Planning & Zoning Commission Regular Meeting
City of St. Peters Justice Center
1020 Grand Teton Drive, St. Peters, MO 63376
September 2, 2026, at 6:30 PM

**STAFF RECOMMENDATIONS TO THE
PLANNING AND ZONING COMMISSION MEETING
SEPTEMBER 2, 2026**

PROJECT MANAGER: NO.	
CHECKED BY: NO.	
DRAWN BY: NO.	
PROJECT NUMBER: 33000504	
CONTENTS	
EXTERIOR ELEVATIONS	
SHEET	
A2.11

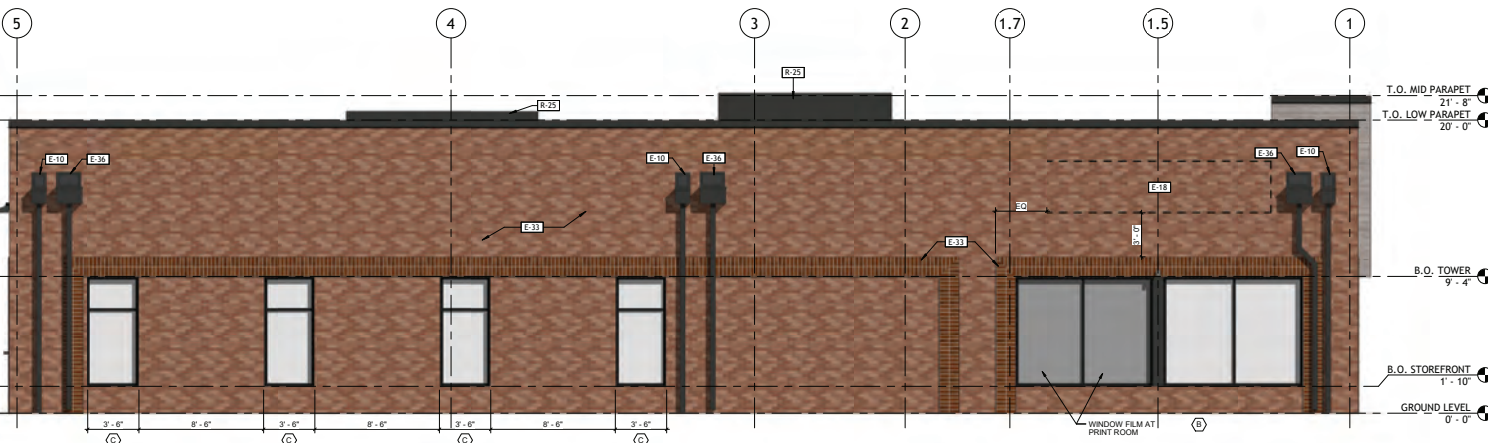
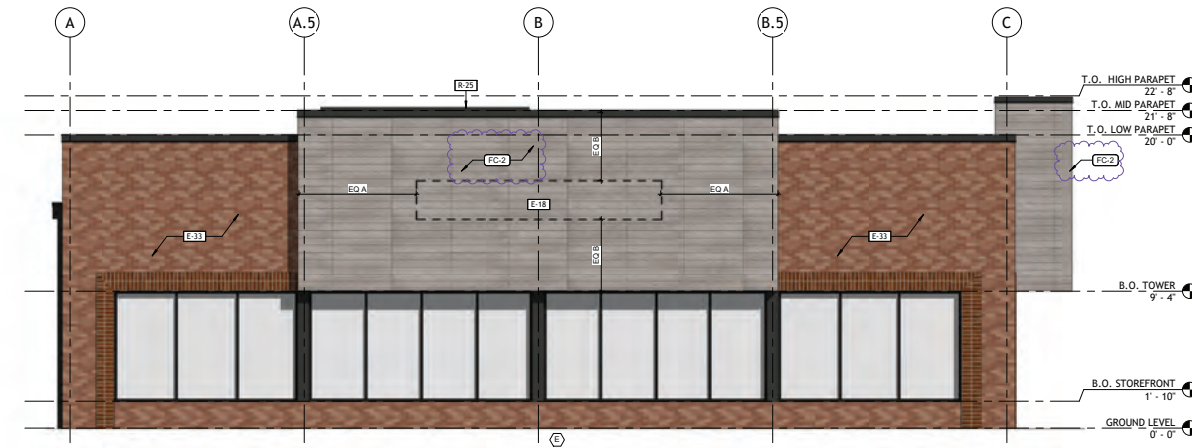
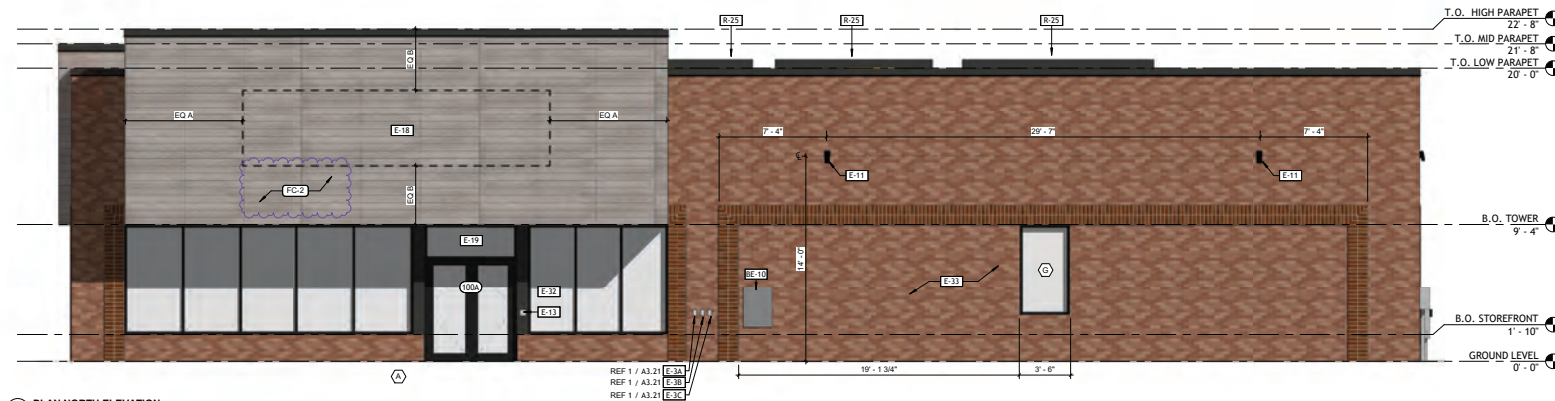
1. Include and coordinate the location of the City's standard general notes.
2. Note on the site plan and elevation drawings all roof top utilities to be screened on all sides to the height of the unit with a architecturally appropriate material.
3. Provide downcast light fixture detail.

NOTE:
ALL ROOF TOP UTILITIES WILL BE SCREENED TO THE HEIGHT OF THE UNITS ON ALL SIDES. GC TO FIELD VERIFY.

18 PAD DETAIL WITH 6 FOOT TALL FENCE N.T.S.

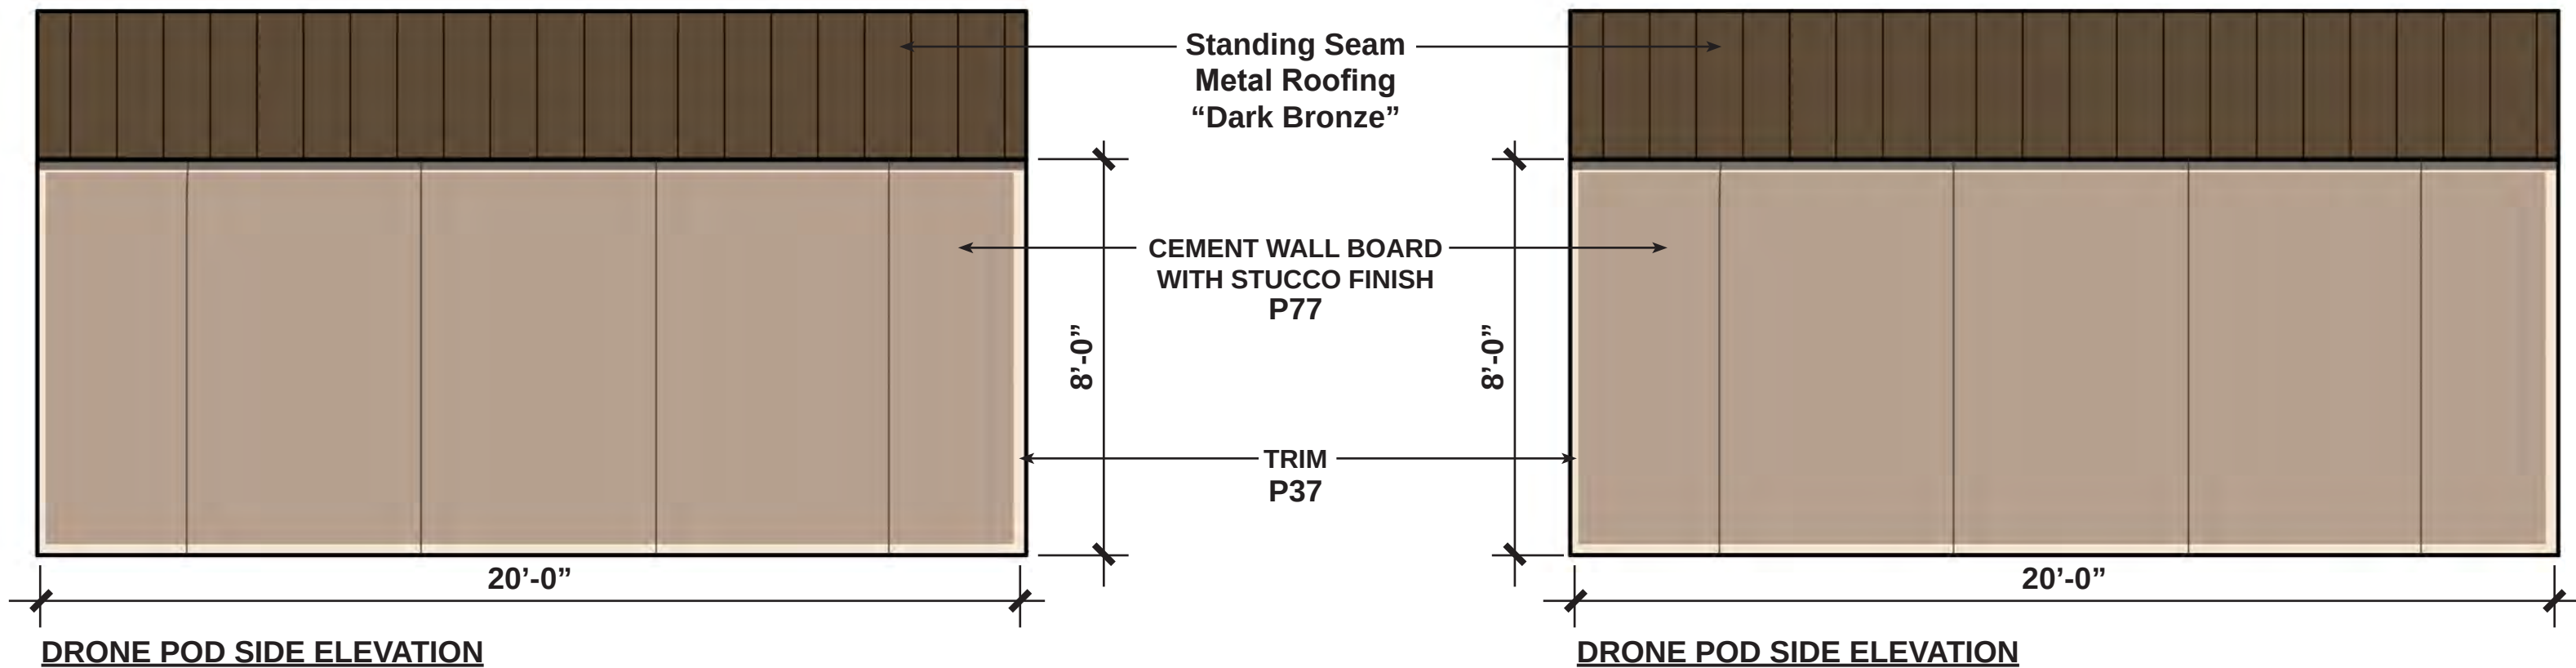
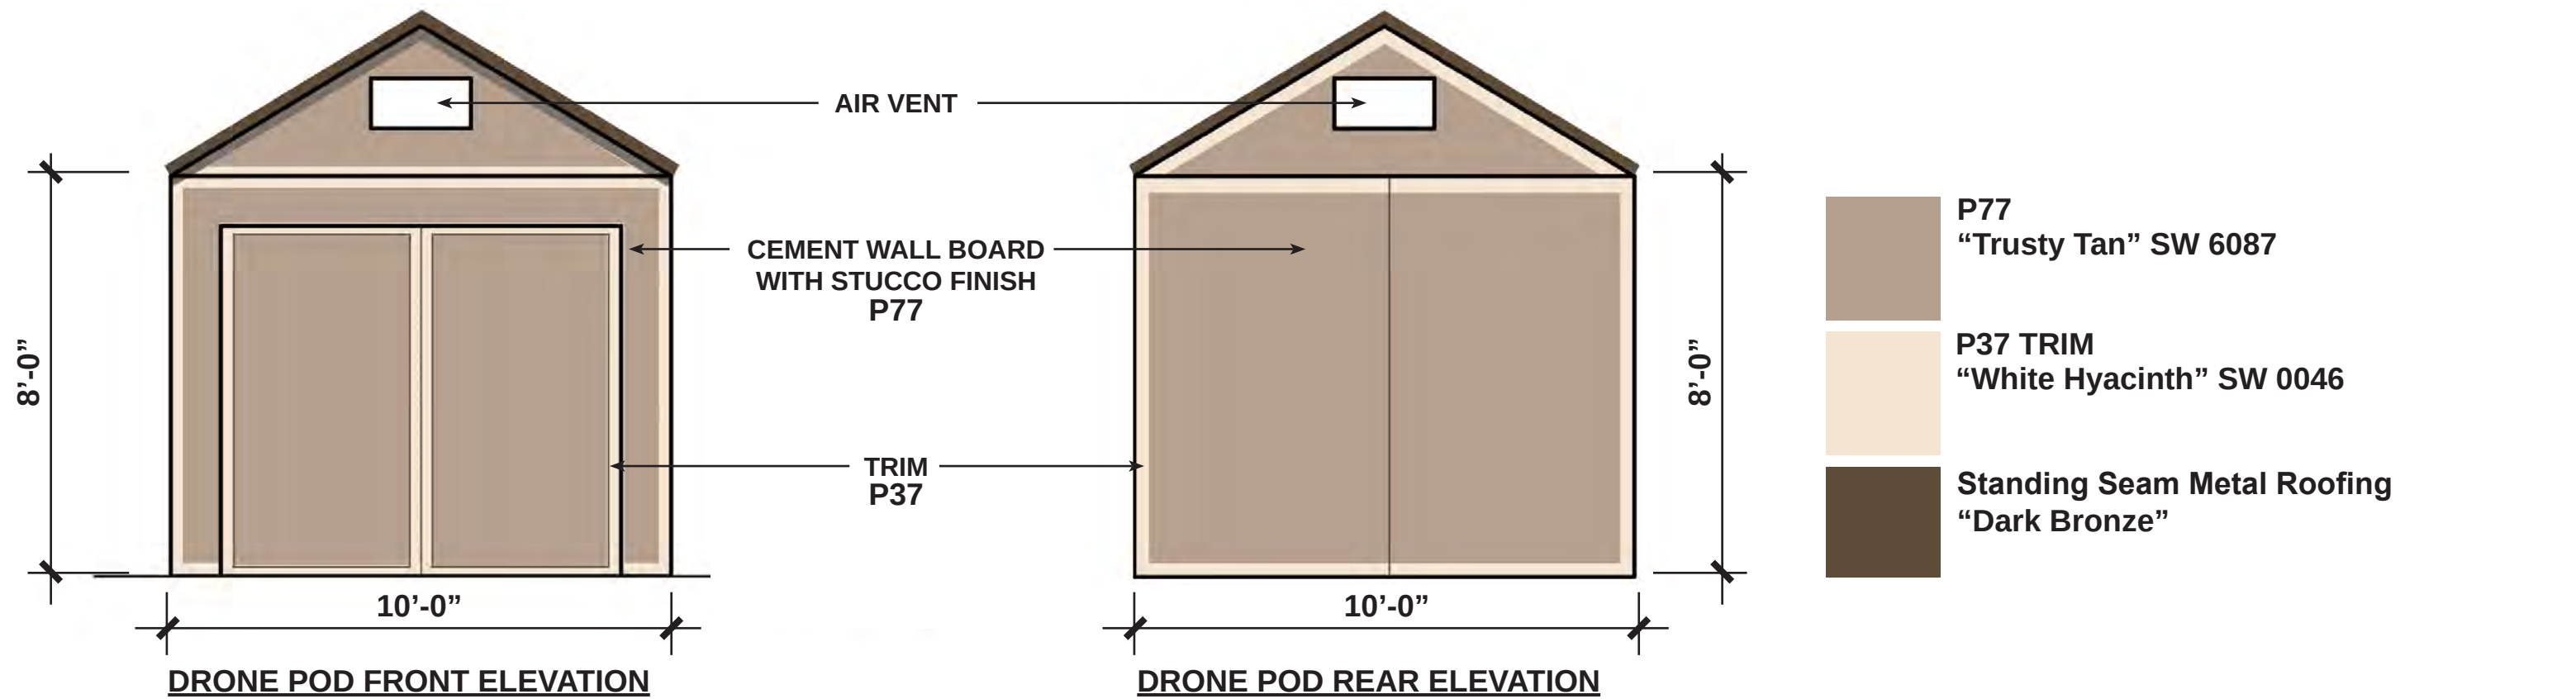
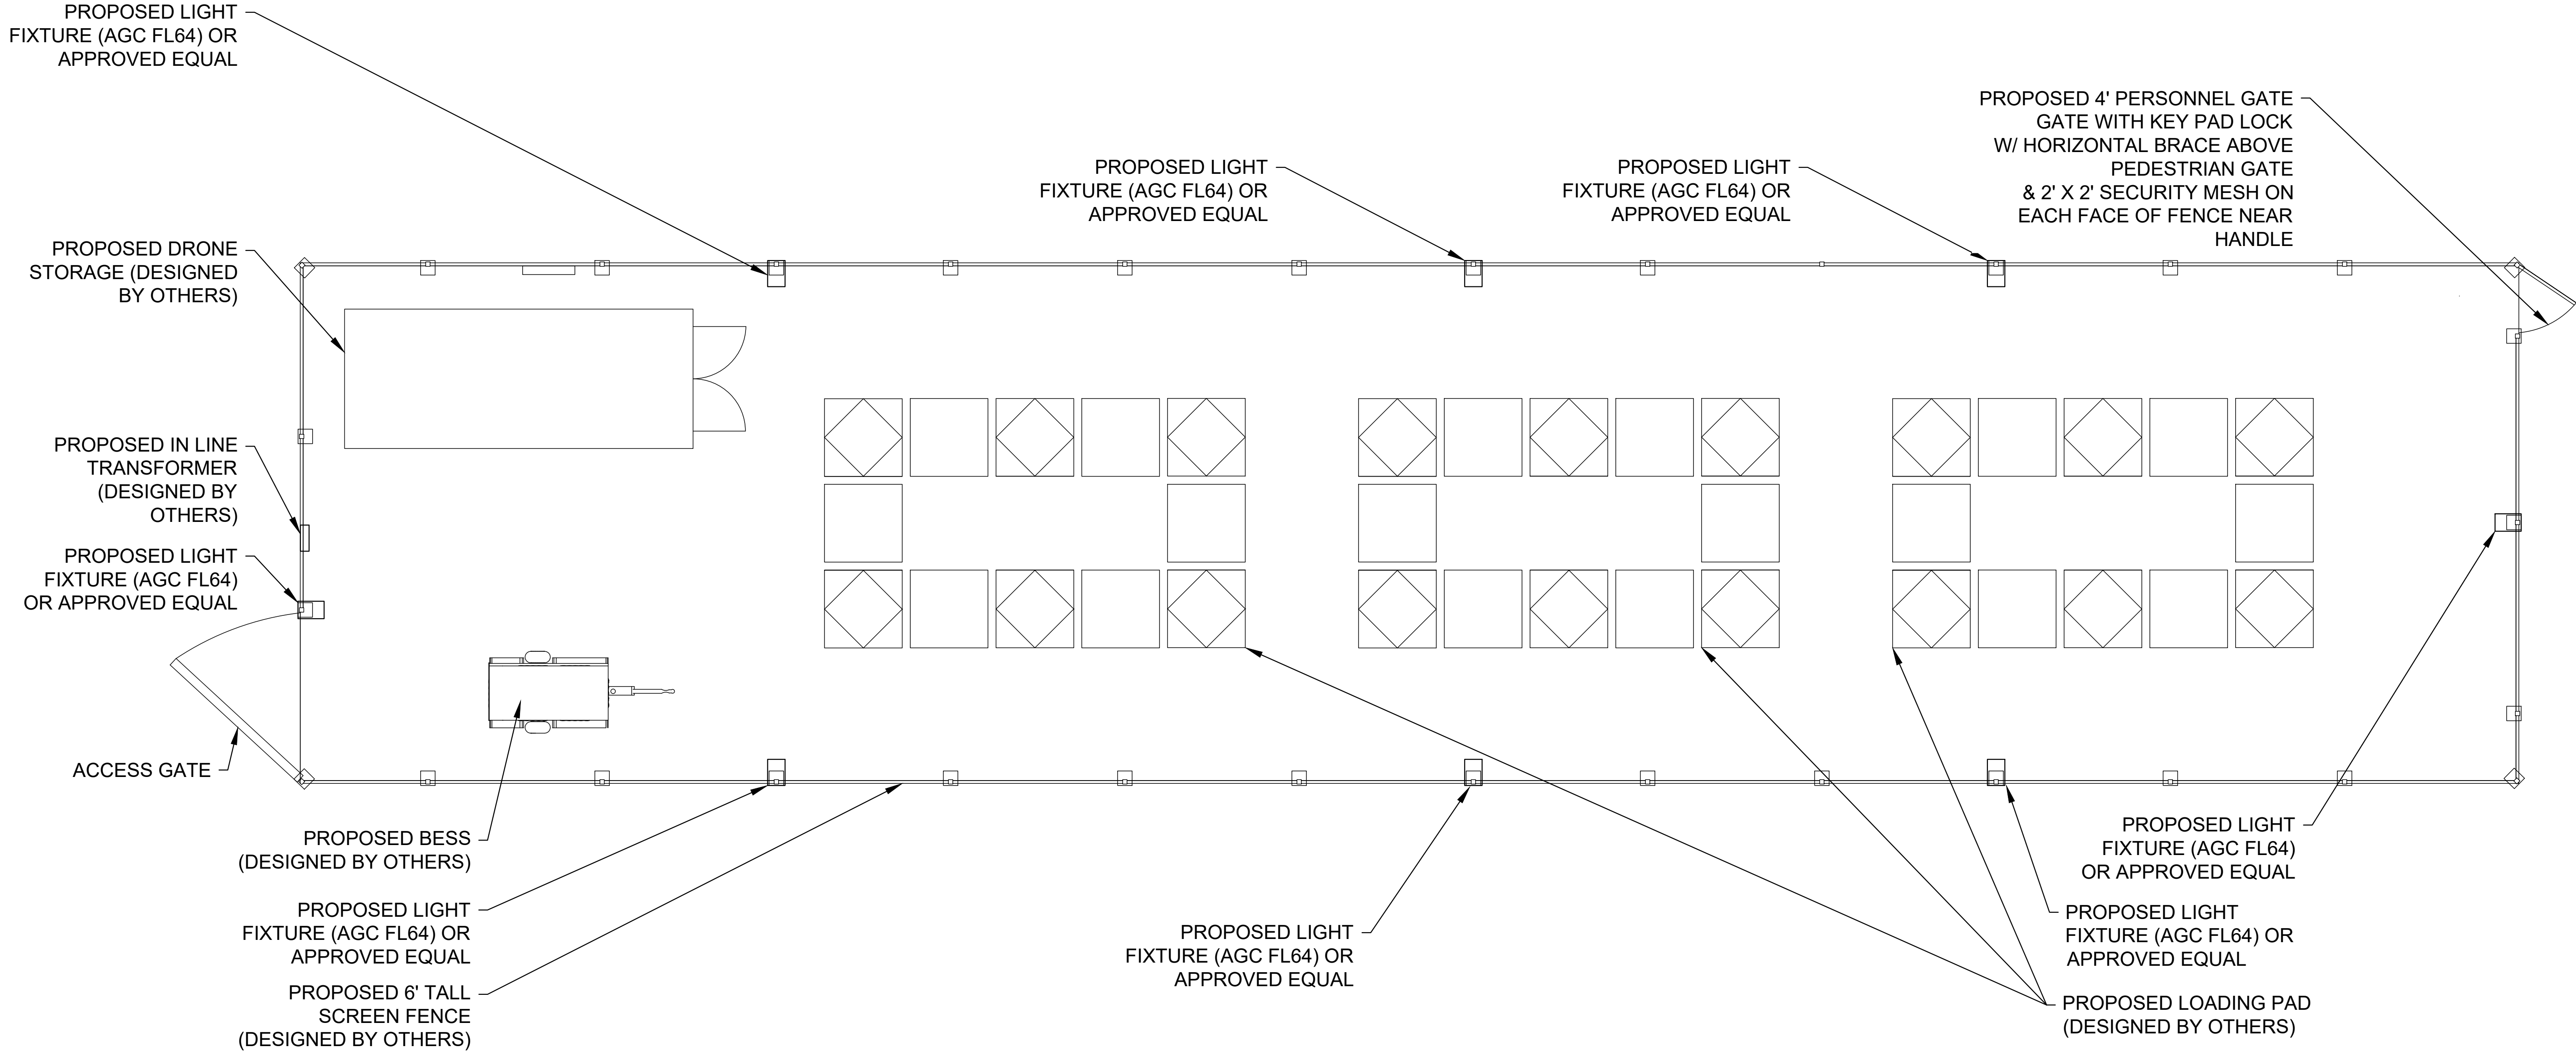
1. Maintain the wrought iron fencing and remove the welded woven wire fence by Wing Fence detail from the plan.
2. Confirm there is no HVAC proposed for the shed. Therefore, no screening will be required for HVAC equipment
3. Confirm that no additional trash enclosures will be required.
